# PLANNING COMMISSION REGULAR MEETING

Monday, April 26, 2021 - 6:00 PM

- 2. Rose - Sackett's Addition Overlay Deviation request** - The request is for approval of a deviation from the requirements of the Sackett Addition Overlay for the construction of an Accessory Dwelling Unit ("ADU") at 334 E. Second Street, Salida, CO 81201

- 3. Jane's Place Planned Development** - The applicant (Chaffee County Community Foundation) is requesting a Major Impact Review to approve a Planned Development for a mixed-use project on a .46 ac. parcel located at the southwest corner of Highway 291 and W. 3rd Street. The general purpose of the hearing is to review and consider the applicant's proposal for a four-building, 17-unit "community housing" development with a variety of dwelling types, as well as commercial and community space.

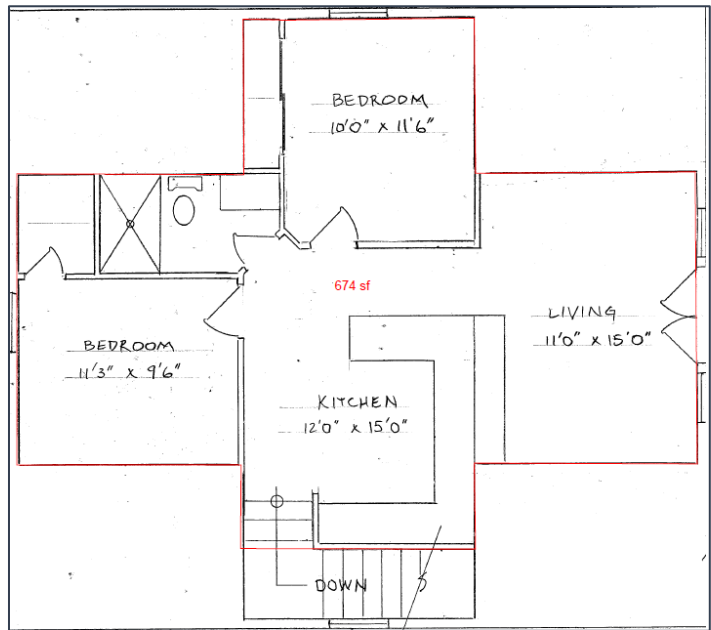
- The floor area of the ground floor is 1,224 square feet. The floor plan shows the total conditioned floor area of the upper level to be approximately 55% of the total floor area (674 s.f. / 1,224 s.f.).

- In the updated floor plans the applicant is showing that the floor area of the upper floor occupies at least 40% of the total floor area of the ground floor. Staff could not verify that the floor area with headroom of 5' or less because the updated plans did not have dimensions of the walls or ceiling height.

1. The applicant must submit scaled plans showing that the ADU meets the story and one half requirement.
2. Approval of this deviation application will expire in two (2) years if a building permit is not applied for the construction of the ADU at this property.

# HEIGHT AND EAVE COMPARISON

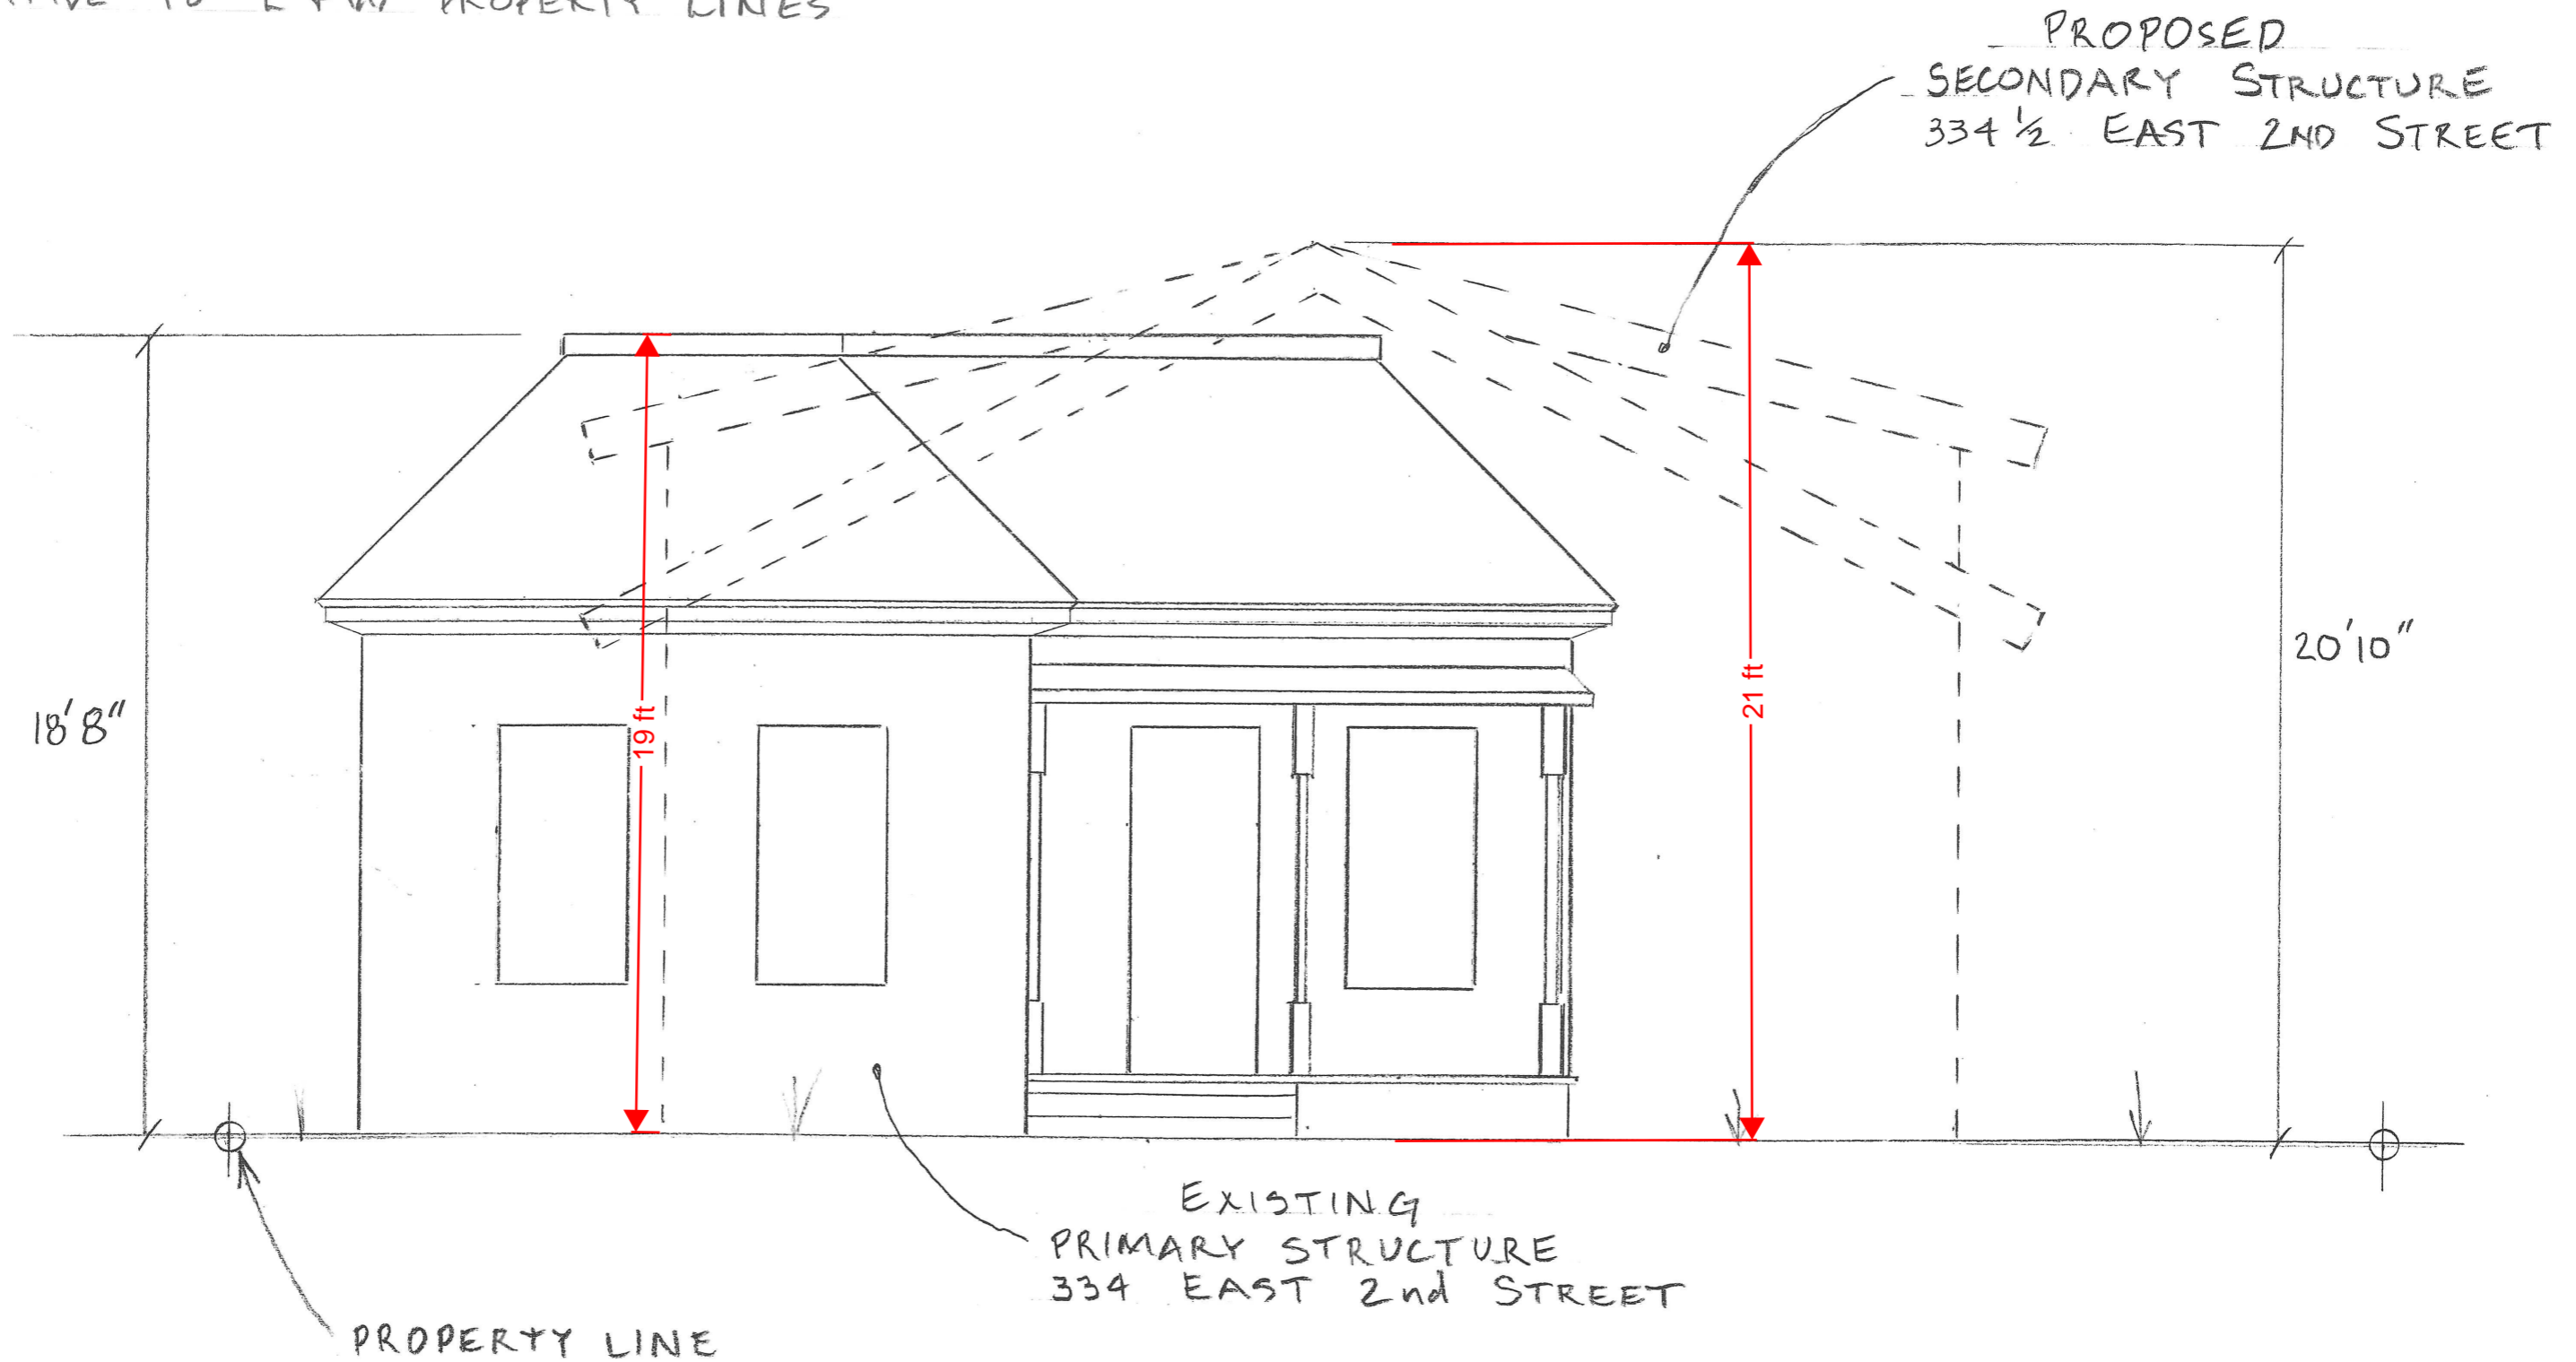
- According to Land Use Code Sec. Sackett's Addition Overlay 16-5-80(C)(3)(i) The maximum height allowed for new accessory structures is one and one-half stories. The height of a new accessory structure must be subordinate to the height of the primary structure.
- The proposed height of the ADU is 20'10" which is 2'2" taller than the existing single-story residence as shown in the application materials. The applicant is showing a grade difference of one foot (1') from the front of the property to the rear and is showing that the actual height difference will be 14".

- With the updated plans the height of the proposed ADU did not change.

The proposed accessory structure at 334 E. Second appears to only meet the detached garage requirement of the ordinance. The proposed structure is taller than the primary structure and from the drawing does not appear to be smaller in mass or scale to the house, nor does it meet the one and one-half story requirement.

- If the deviation request is approved the applicant must show how the ADU meets the story and one-half requirement with scaled drawings.
